**SERVICING AND STORMWATER
MANAGEMENT REPORT
Residential Apartment Buildings**

6173 RENAUD ROAD
OTTAWA, ONTARIO

PROJECT #: 190867

Rev 0 – Issued for Site Plan Approval
Revision 1 – Issued in Response to Review Comments
Revision 2 – Issued to Address Review Comments and Revised Site Plan
Revision 3 – Issued in Response to Review Comments
Revision 4 – Issued in Response to Review Comments
Revision 5 – Issued in Response to Review Comments

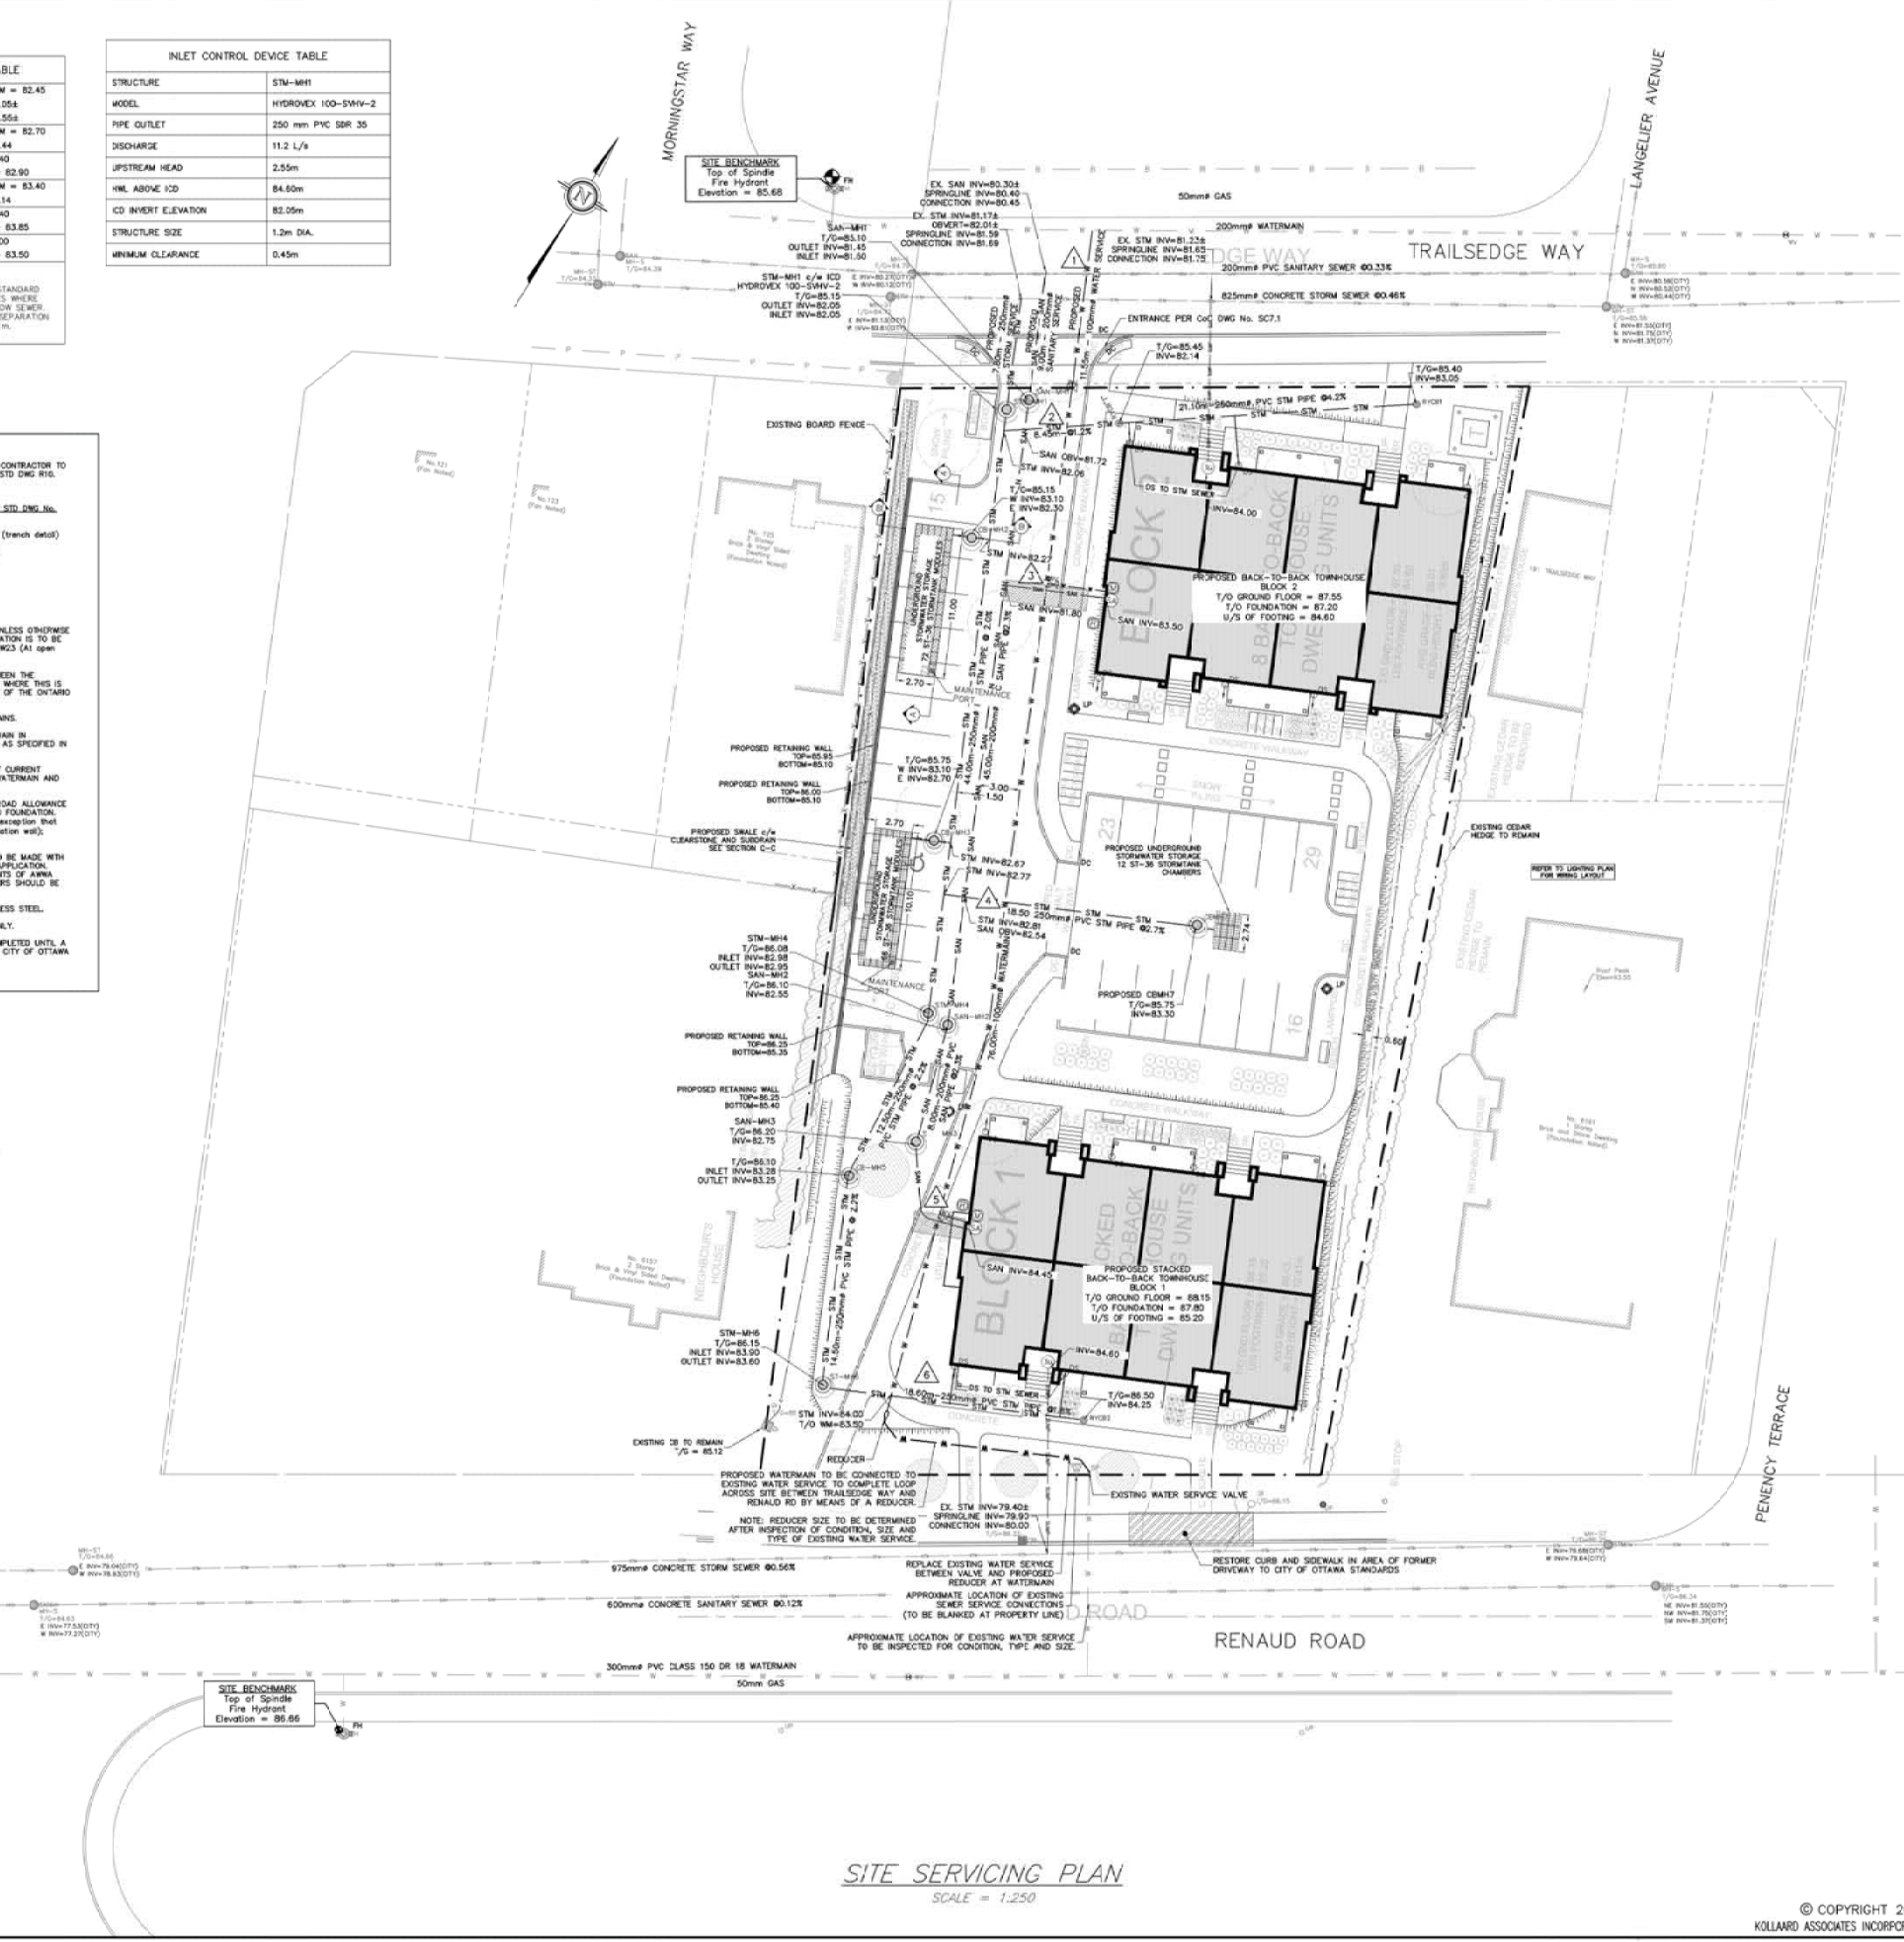
9. Servicing plan shows in plan view an ICD at MH1 while the table on the same page shows the ICD in MH2?

See comment #1 on ICD Table.

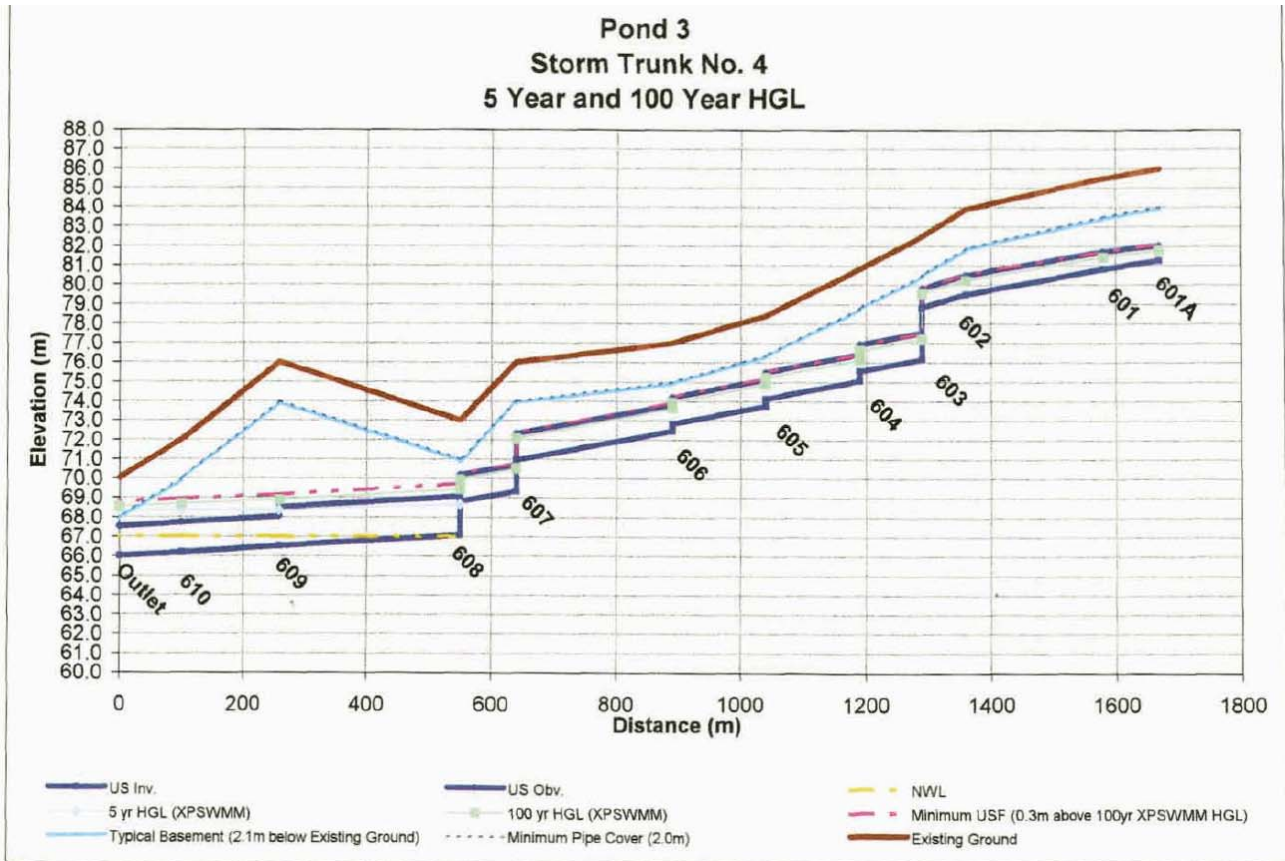
3. There is no discussion on the hydraulic grade line (HGL). There should be some discussion on the boundary condition and sewer design guideline (SDG) criteria of the HGL relative to the underside of footing.
